2.0 Design of Fourth and Fifth floor façades

Proposed Fourth Floor Plan

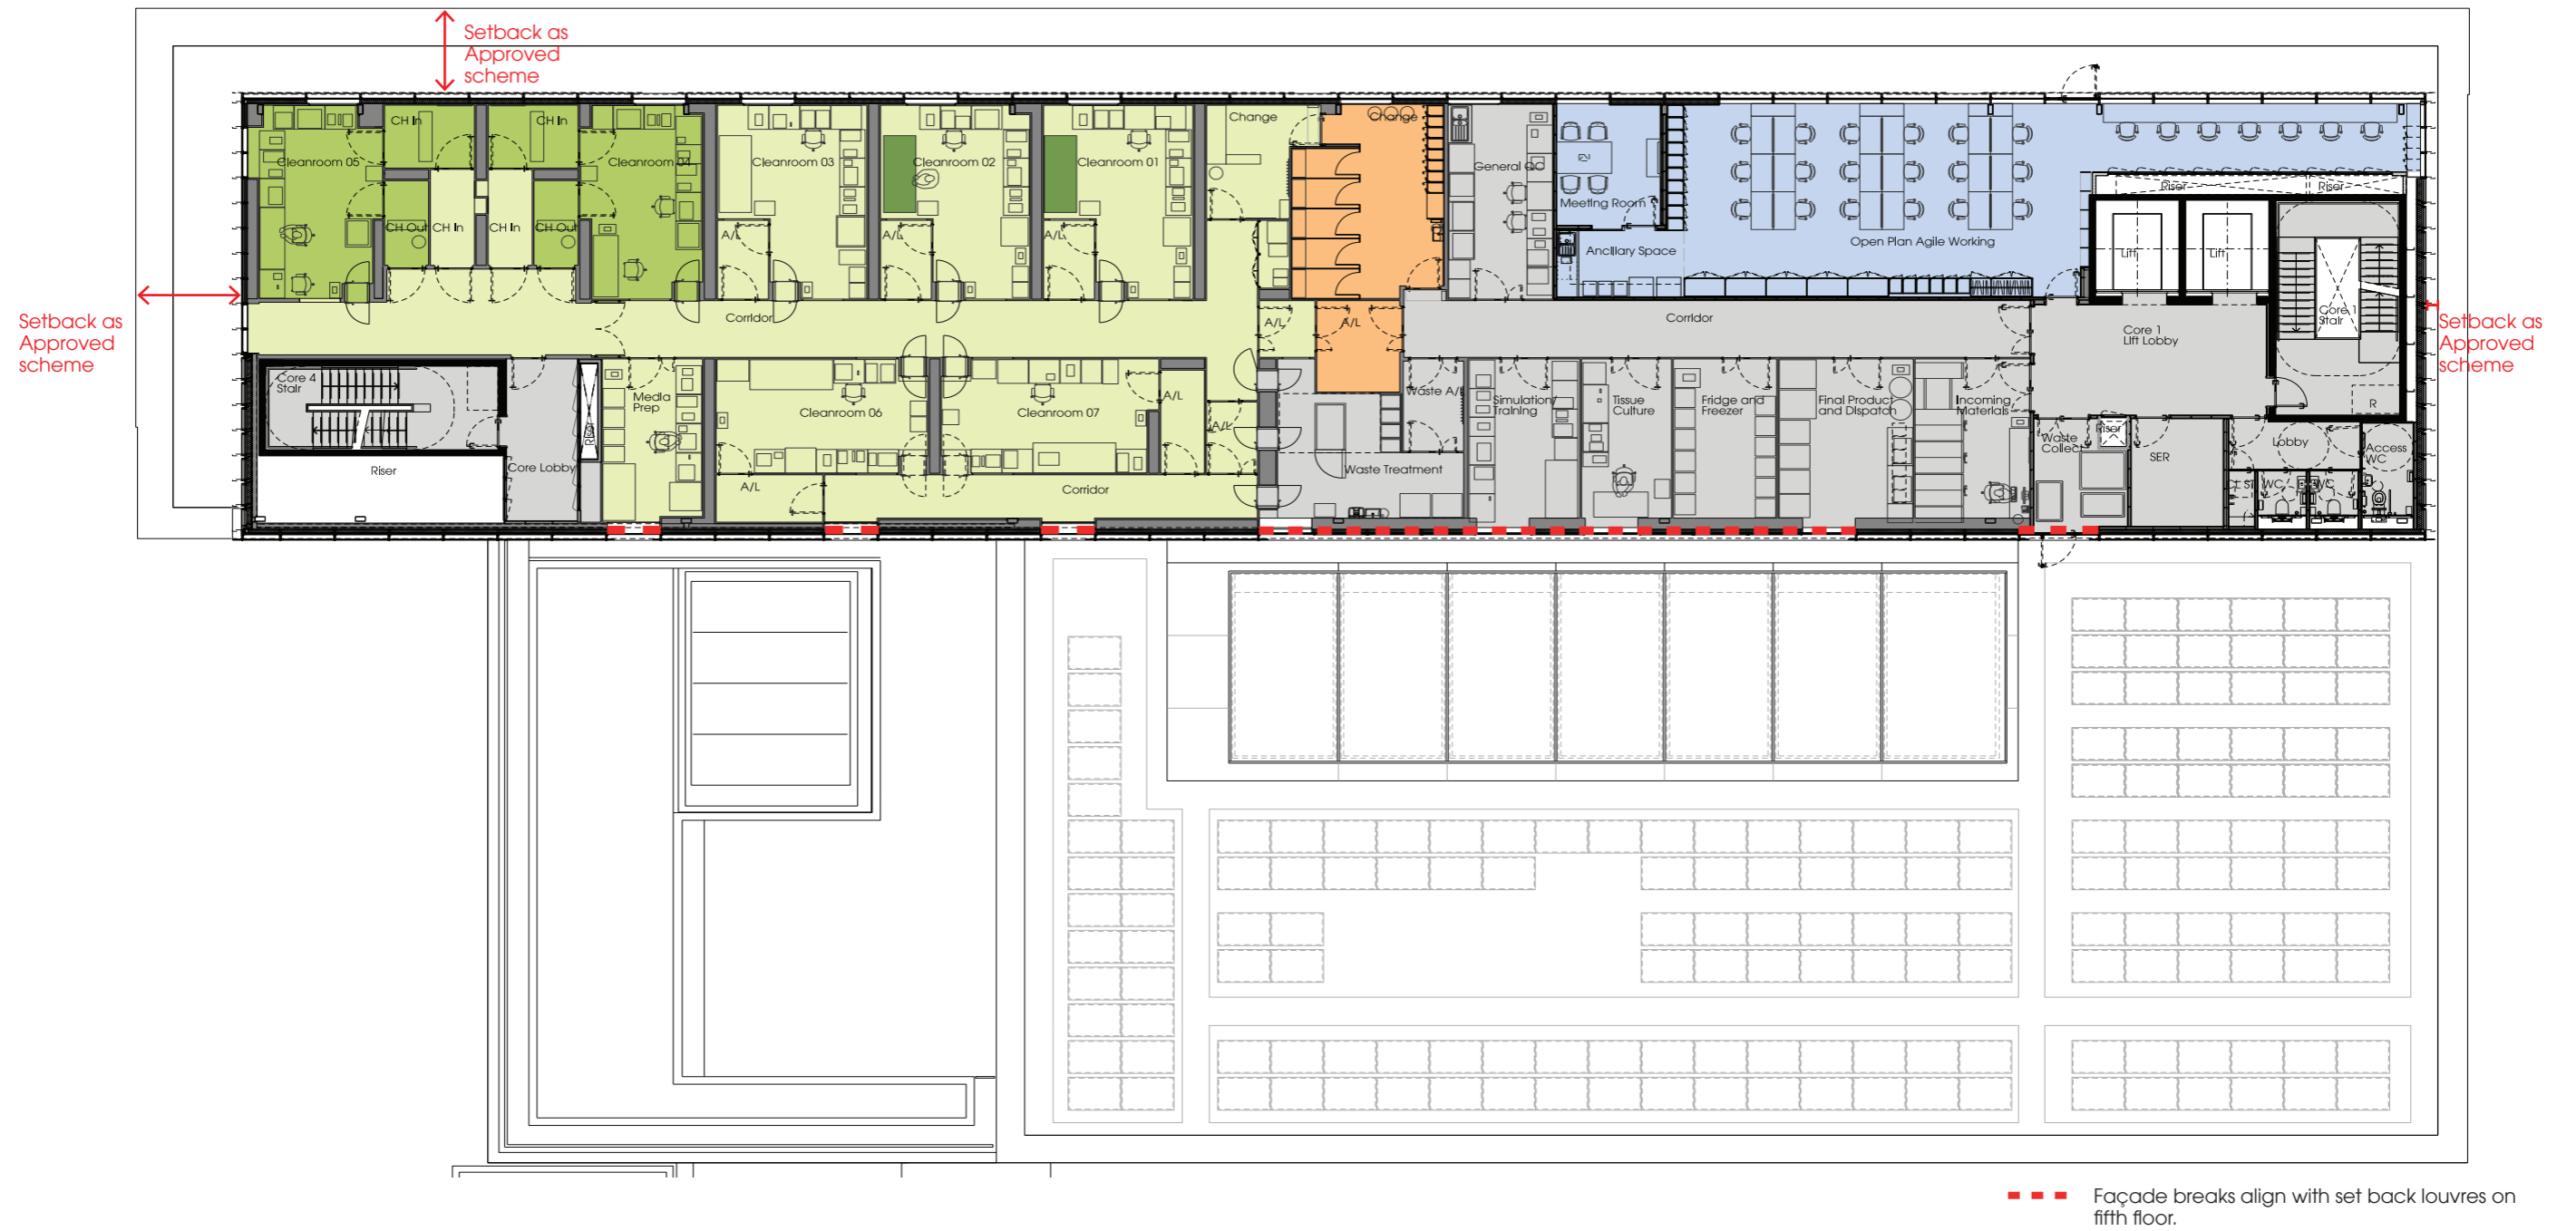
On the south elevation, due to detailed design development of the plant areas, it is proposed to group the fifth floor intake louvres in one uniform bank. This stretch of louvres will align with the facade break on the fourth floor, providing clear glazing into technical spaces. Additional facade breaks will be positioned in a regular rhythm, spanning both fourth and fifth floor, in a similar manner to those in the consented scheme. As on the north elevation, the louvres here will have a frameless appearance and will match the design elsewhere.
